JX6-SB(-I)
Version Update
from V. 2.16 to V. 2.18

2.4 JX3 Modules

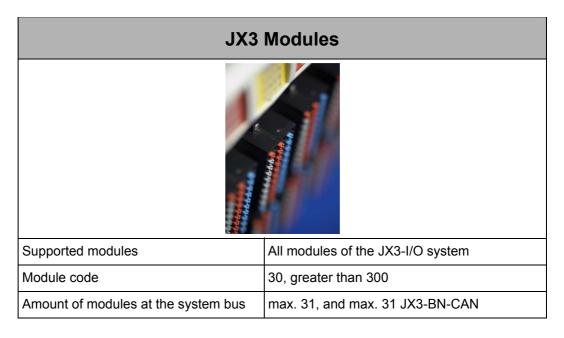
As of version 2.18, the JX6-SB(-I) module supports the modules of the JX3-I/O system. The functional range of the JX3 modules has been described in the respective user manuals.

The registers and I/Os are numbered the same way as the non-intelligent JX2-I/O modules.

2.5 LioN-S Modules

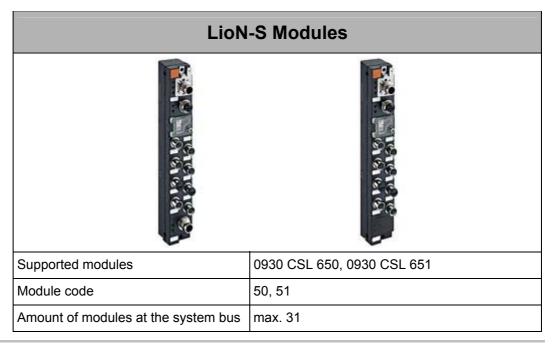
As of version 2.18, the JX6-SB(-I) module supports LioN-S modules of protection class IP 67. The functional range of the modules has been described in the respective user manuals. The registers and I/Os are numbered the same way as the non-intelligent JX2-I/O modules.

Numbering of the Digital Inputs/Outputs at JC-647

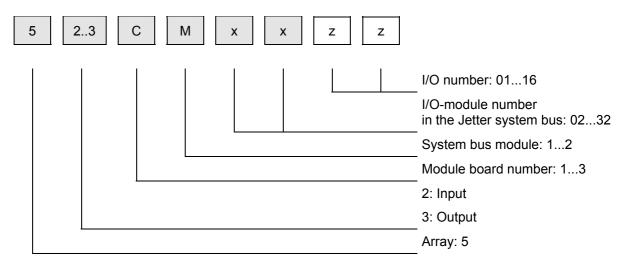
The addresses, respectively the module numbers 2 through 32 are now also supported within the Compactbox modules LJX7-CSL.

The I/O registers are numbered the same way as the I/O registers of the JX2-I/O modules.

2.8 Milan Drives

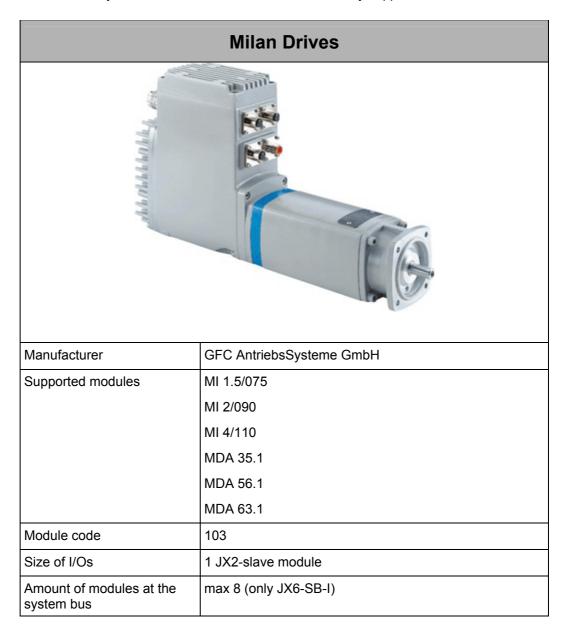
Starting from this operating system version, the "Advanced" configuration of the Milan Drives made by Werner Riester GmbH & Co KG is directly supported.
